Proposal for draft Supplement 5 to Regulation No. 129

The text reproduced below was prepared by the expert from Spain on behalf of the Technical Services Group (TSG) on Regulation No. 44 and Regulation 129. The modifications to the current text of Regulation are marked in bold for new or strikethrough for deleted characters.

II. Proposal for draft Supplement 1 to the 01 series of amendments to Regulation No. 129

Load application device II

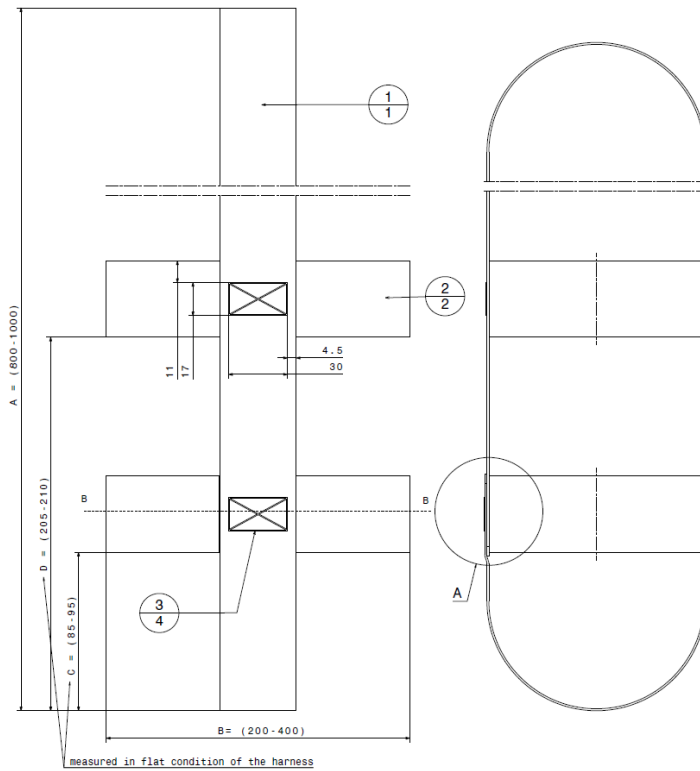
Annex 21, modify figure of Load Application device II, by adding the text “measured in flat condition of the harness”

Load application device II

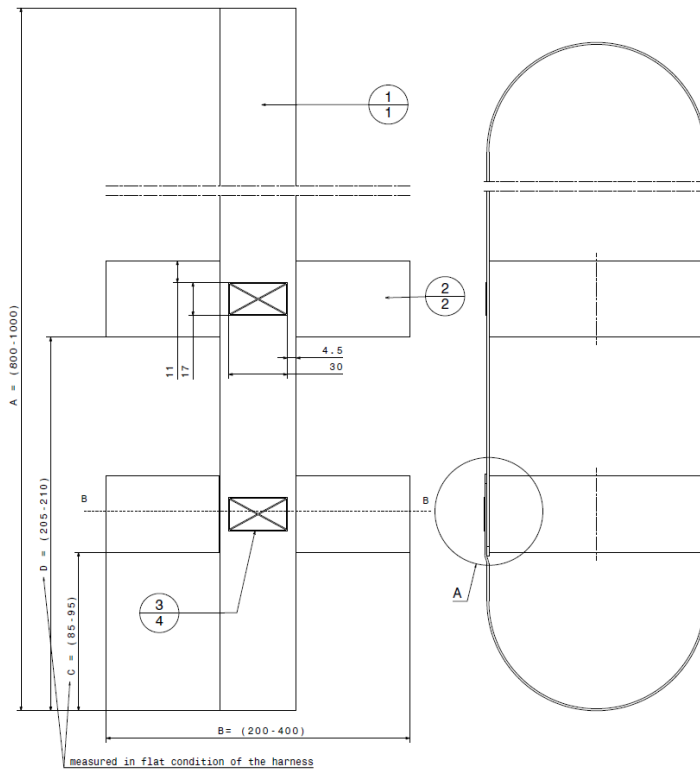
Annex 21, modify figure of Load Application device II, by adding the text “measured in flat condition of the harness”
